**INDEPENDENT ADVISORY
PANEL FOR UNDERGROUND
MINING**

**DENDROBIUM COAL MINE
LONGWALL 19
SUBSIDENCE MANAGEMENT PLAN**

February 2021

Figure 1: High resolution closure line survey data from monitoring of Sandy Creek waterfall associated with extraction of LW7 and LW8 in Area 3A (Figure 9 in Walsh, Mills, et al. (2014))

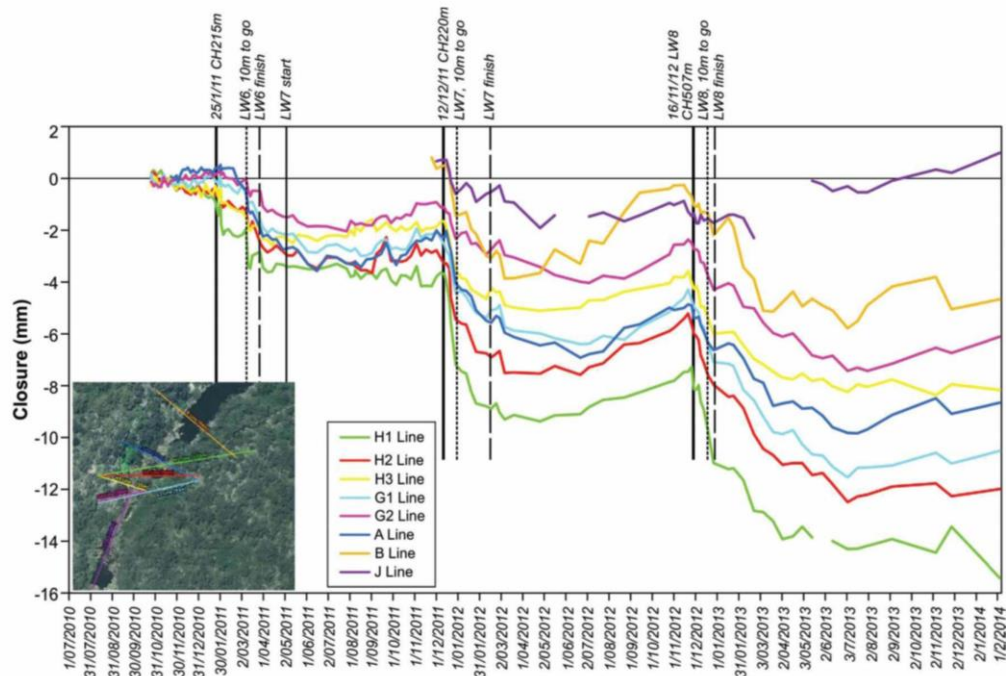
A challenge faced by the project was deciding how much valley closure the waterfall could tolerate without exceeding the performance measures specific in the Approval Conditions. Walsh, Mills, et al. (2014) report that during the lead up to the first precautionary stoppages in LW6, it became clear that the conventional three-dimensional survey lines previously installed and surveyed at the site were not going to be sensitive enough to detect the very low level deformations that stress cells were indicating. In response to this realisation, a network of eight high resolution one-dimensional survey monitoring points was established across Sandy Creek

Waterfall and the incised valley immediately downstream. Figure 1 shows the location of these lines and the movements that were observed.² Table 1 summarises incremental and cumulative valley closures for survey line H1.

It is recommended that the closure across the waterfall is measured monthly during the first 1000 m of mining of LW19. A Trigger Action Response Plan (TARP) should also be established based on these measured movements.

- Although an incremental increase in predicted closure of less than 5 mm may appear a trivial value in absolute terms, it is significant when regard is had to the amount of closure associated with the cessation of extraction of LW6, LW7 and LW8.
- As a matter of due diligence, the Technical Committee formed under the Sandy Creek Waterfall Management Plan should be engaged in determining the setback distance of LW19 from the waterfall and the appropriateness and robustness of the monitoring plan and associated trigger levels and responses.

1. The Department embrace the proposal of South32, dated 15/1/2021, that the Sandy Creek Waterfall Management Plan be re-established and applied to the extraction of LW19.
2. The starting location of LW19 and the proposed monitoring plan and its associated triggers and responses should take into account the latest field survey results and be endorsed by the Technical Committee previously constituted for the Sandy Creek Waterfall.

Figure 2. Extract from Drawing DEN-01-7783 from the SMP showing the location of Swamp 15a relative to LW19

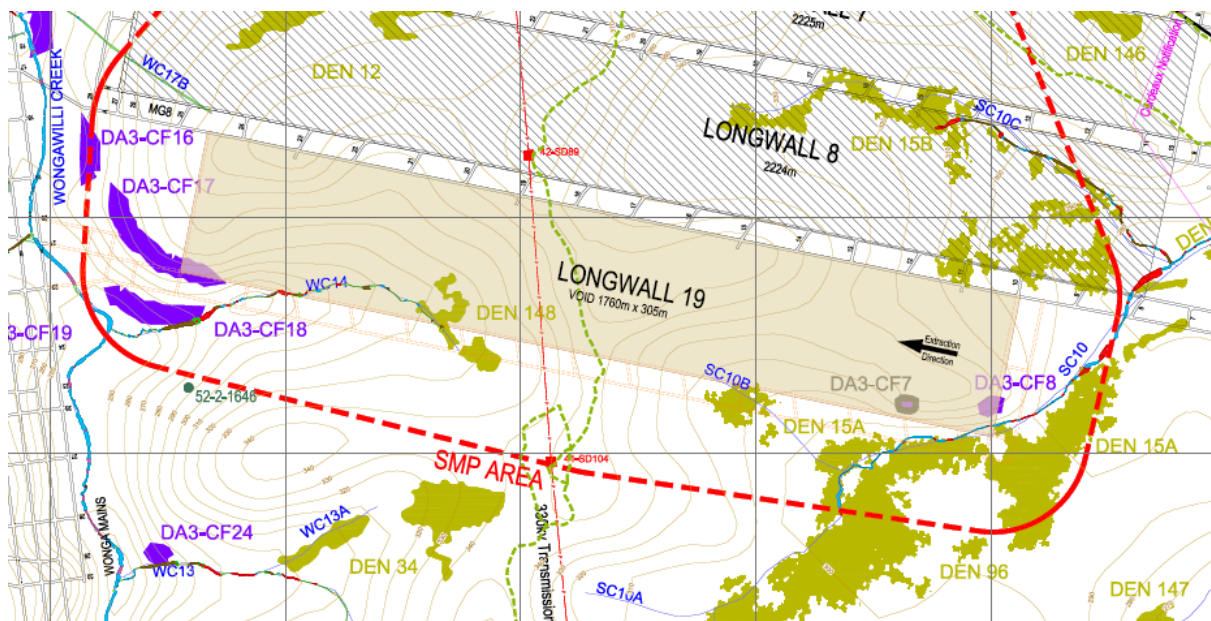
The footprint of Swamp 15a is shown in Figure 2. A significant point of note is that a portion of Swamp 15a is located over the upper reaches of SC10B and abuts and partially overlies the footprint of LW19.³ It has the potential to seriously impact the permissible length or width of LW19 given the Consent Conditions relating to Swamp 15a.

With the present Consent Condition for Swamp 15a, the southern edge of LW19 needs to be offset at least 60 m from the edges of Swamp 15a. This requires either a narrowing or a reduction in the length of the longwall to substantially reduce the likelihood of a change in ecosystem functionality. Monitoring of performance would still be needed. To date, vegetation changes – swamp size; species richness, distribution, composition and diversity; vegetation sub-communities – have been used as surrogates for ecosystem functionality for approvals of mining to date in Dendrobium. The Proponent proposes to continue with this approach (South 32, 2020 - SIMMCP Table 6.1).

With the current longwall layout, the Panel considers it predictable with a high level of certainty that the proposed LW19 will result in changes in ecosystem functionality in parts of

Swamp 15a within 60 m of the longwall. This is based on the significant changes to swamp groundwater levels observed within that distance at other swamps in the Dendrobium mining area (Watershed HydroGeo, 2019). The Panel notes that 7 or 9 % of the swamp would be within 60 m of the proposed longwall (both figures are noted in SMP Section 5.3.3).

This layout would certainly fail to meet the performance measure required under Condition 5. Regarding the proposed groundwater performance indicators in Table 1.2 of the SIMMCP, the Level 1 indicator would almost certainly be surpassed if any of the monitoring points were within the 60 m threshold, while the Level 2 and 3 indicators are unlikely to be surpassed as they require increasing proportions of the monitoring points to be affected. The other indicators related to ecosystem functionality may not be surpassed on a useful time-scale for reasons covered previously.

- As a minimum requirement to meet Condition 5 regarding ecosystem functionality of Swamp 15a, LW19 should be set back at least 60 m from all edges of Swamp 15a.
